Construction Site Management Plan Checklist

Project Name: Gondola & Building B

Steamboat Logistics Base Improvements

CSMP Gondola Building and Building B Demo.

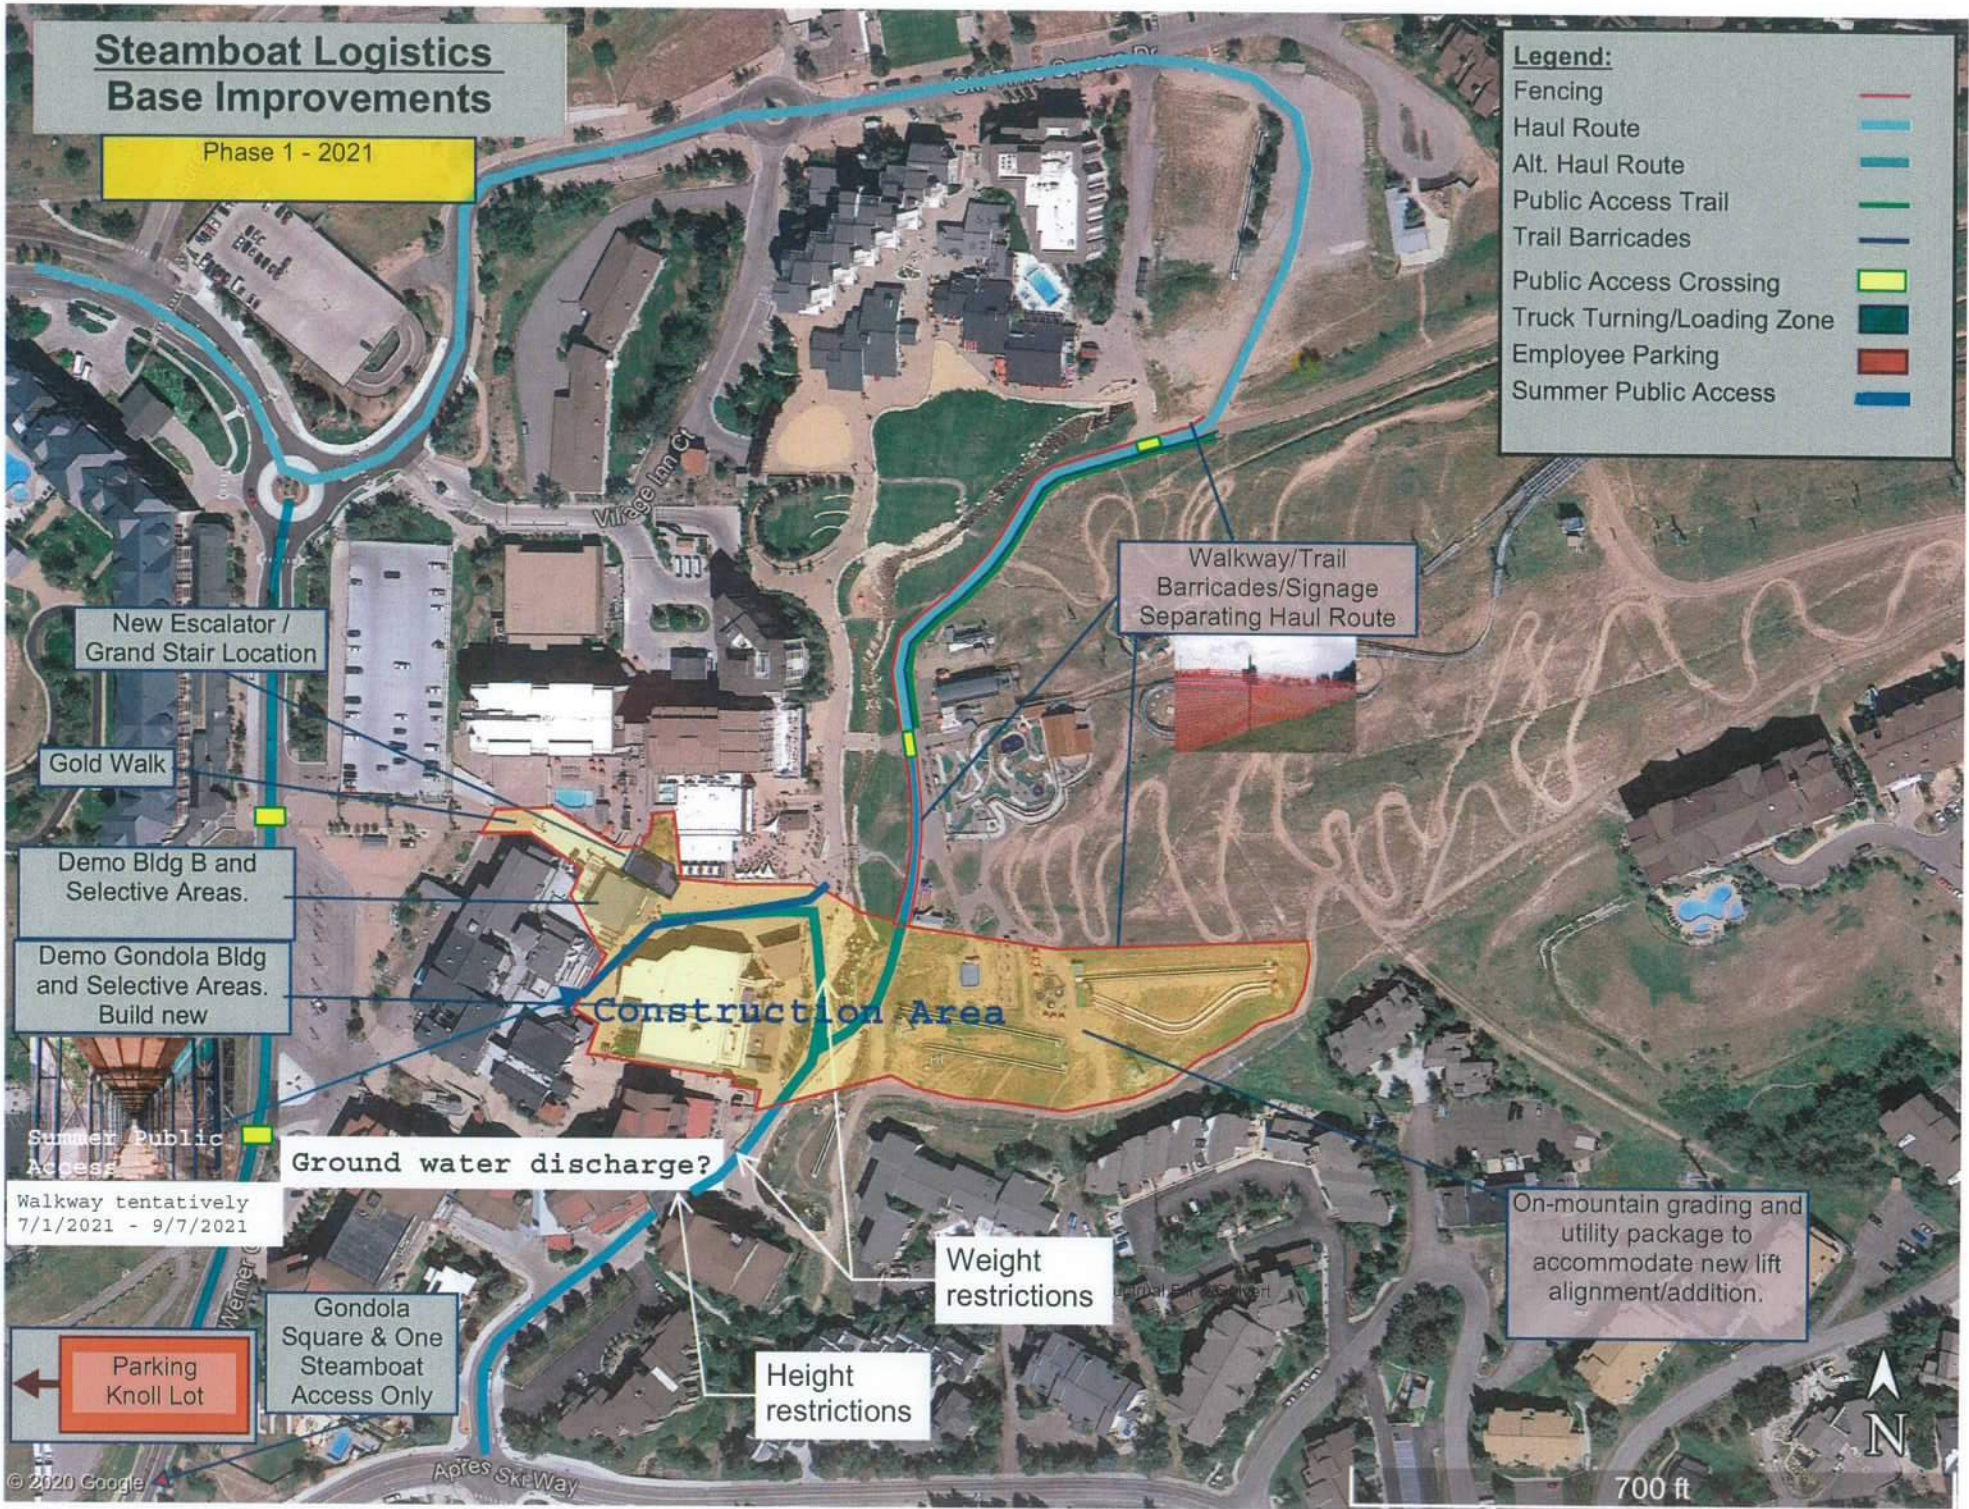
where on plan?
I see the details, i dont see the locations.
